FINAL DRAINAGE REPORT

SETTLERS RANCH SUBDIVISION FILING NO. 3

April 22, 2024
Revised July 27, 2024

JPS Project No. 030501
El Paso County PCD File No. SF-249

PBMP
APPLICABILITY EXHIBIT

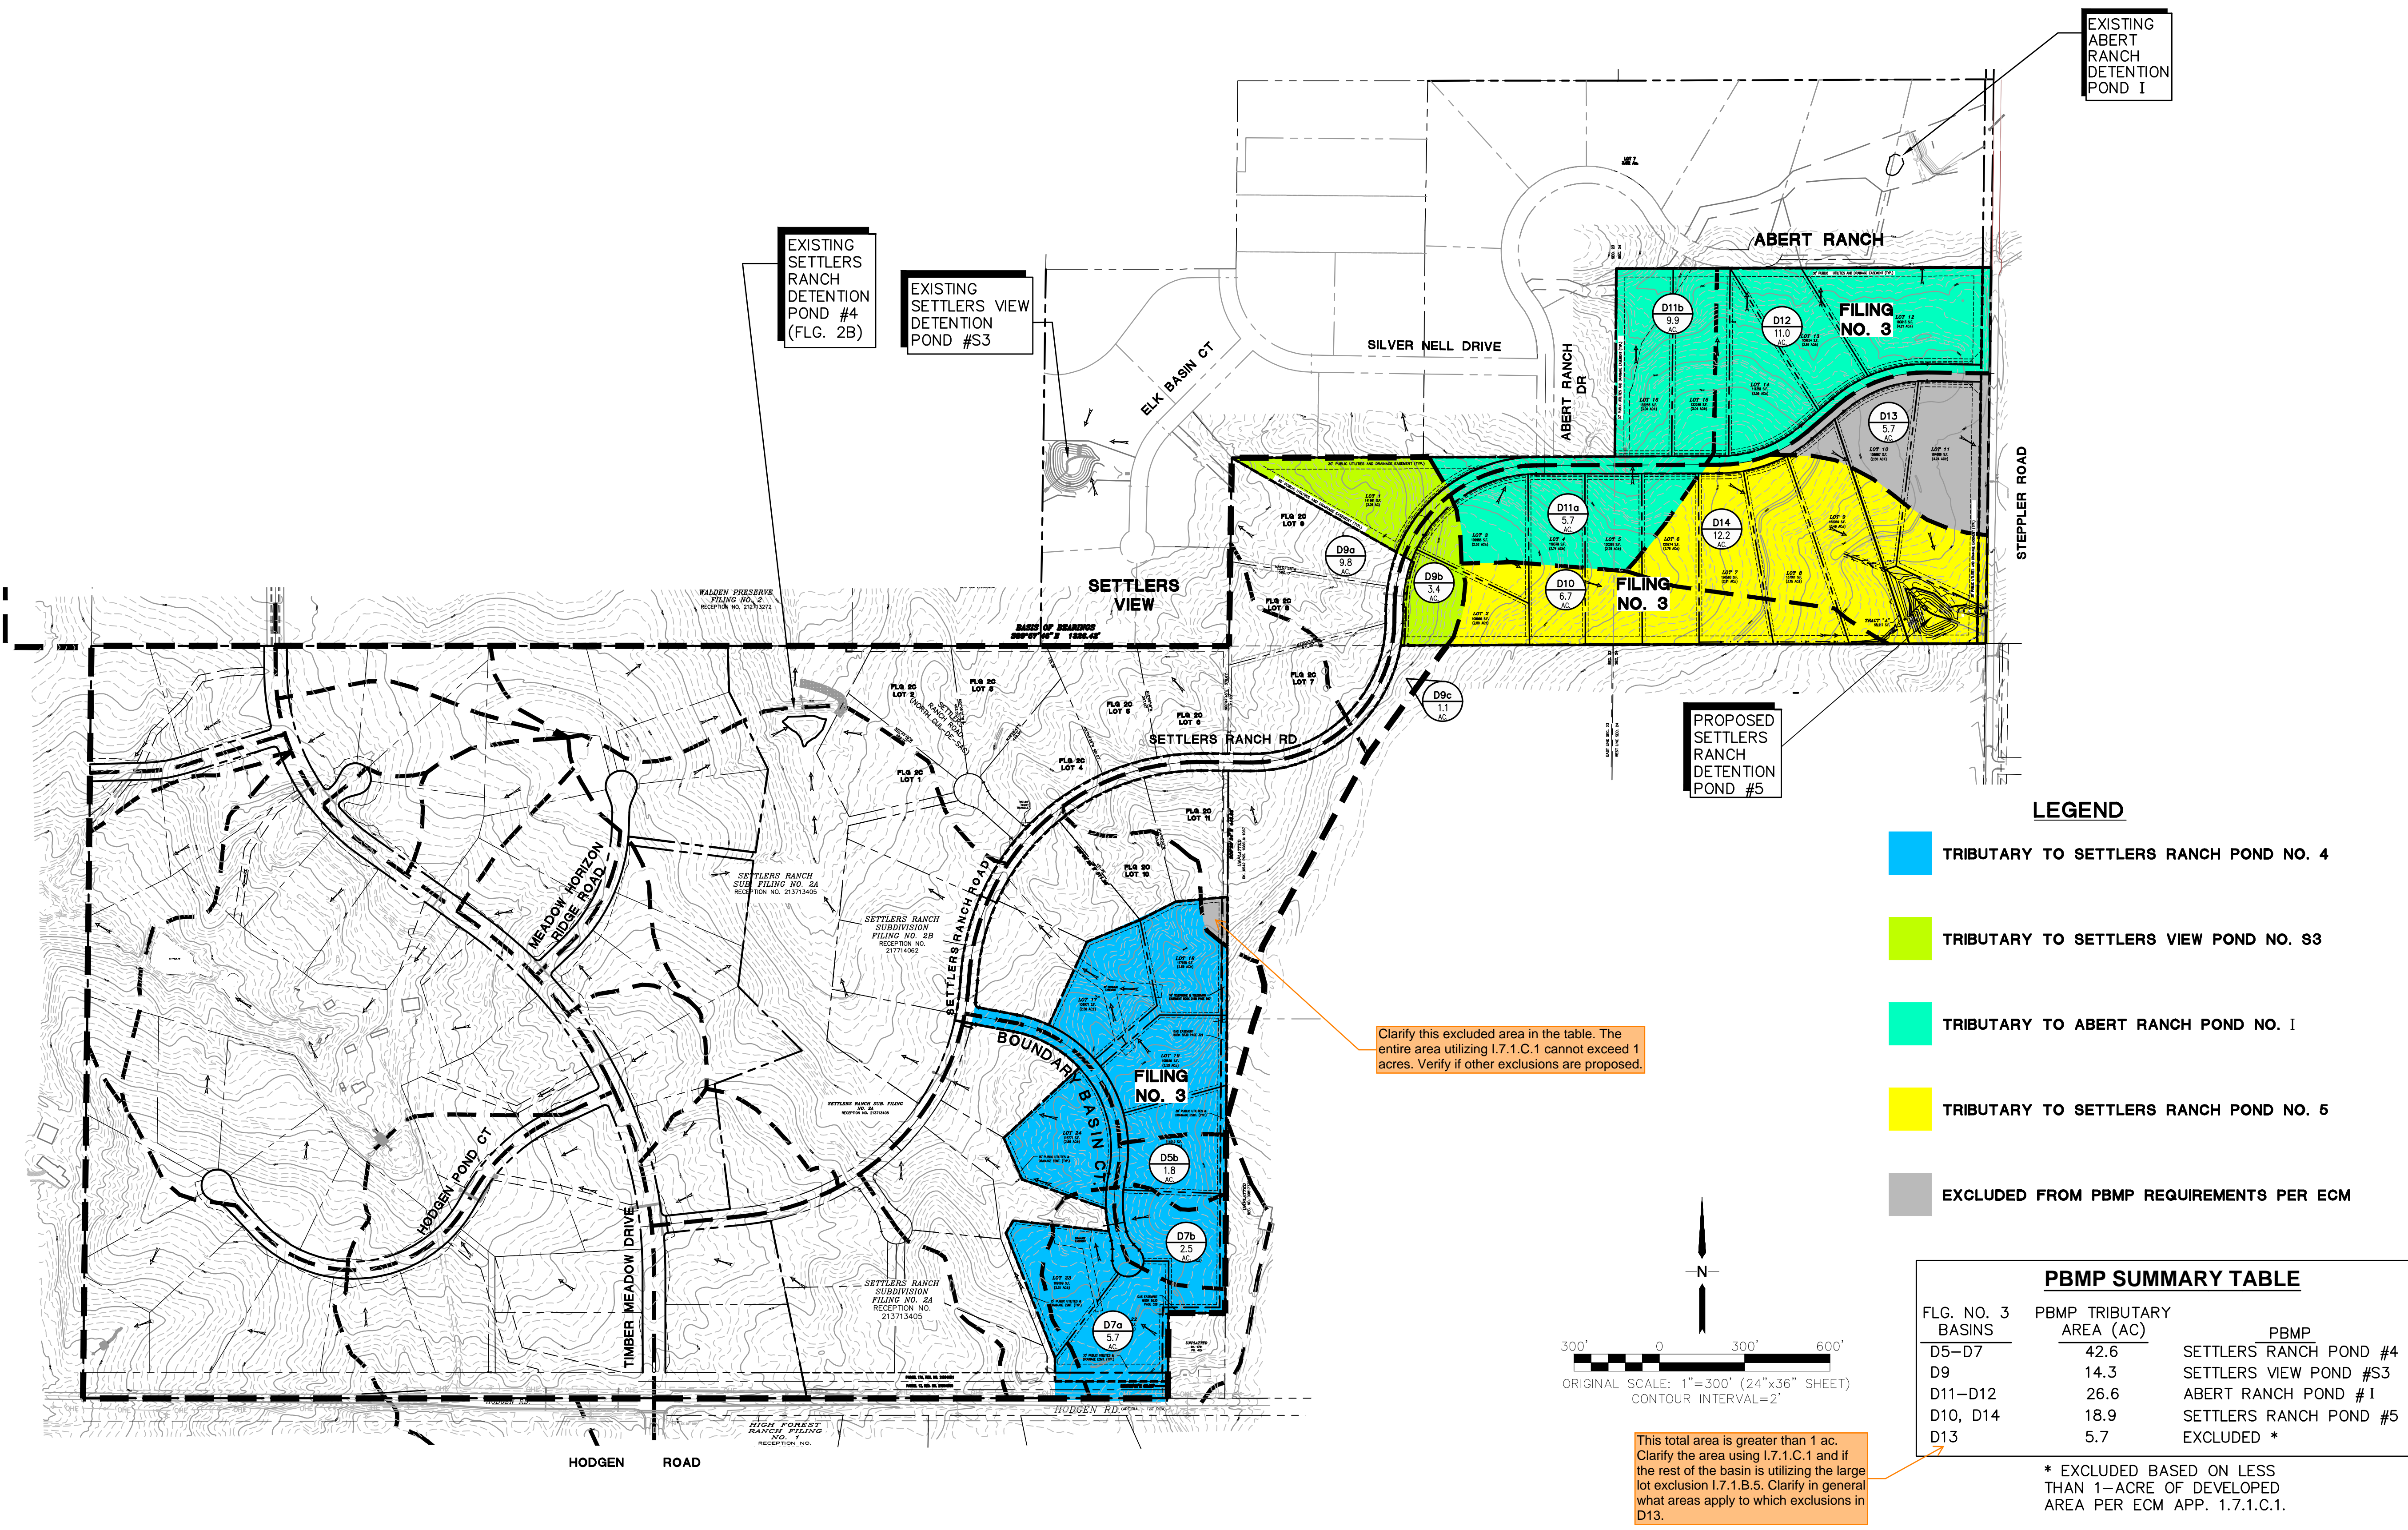
This total area is greater than 1 ac. Clarify the area using I.7.1.C.1 and if the rest of the basin is utilizing the large lot exclusion I.7.1.B.5. Clarify in general what areas apply to which exclusions in D13.

This total area is greater than 1 ac. Clarify the area using I.7.1.C.1 and if the rest of the basin is utilizing the large lot exclusion I.7.1.B.5. Clarify in general what areas apply to which exclusions in D13.

Clarify this excluded area in the table. The entire area utilizing I.7.1.C.1 cannot exceed 1 acres. Verify if other exclusions are proposed.
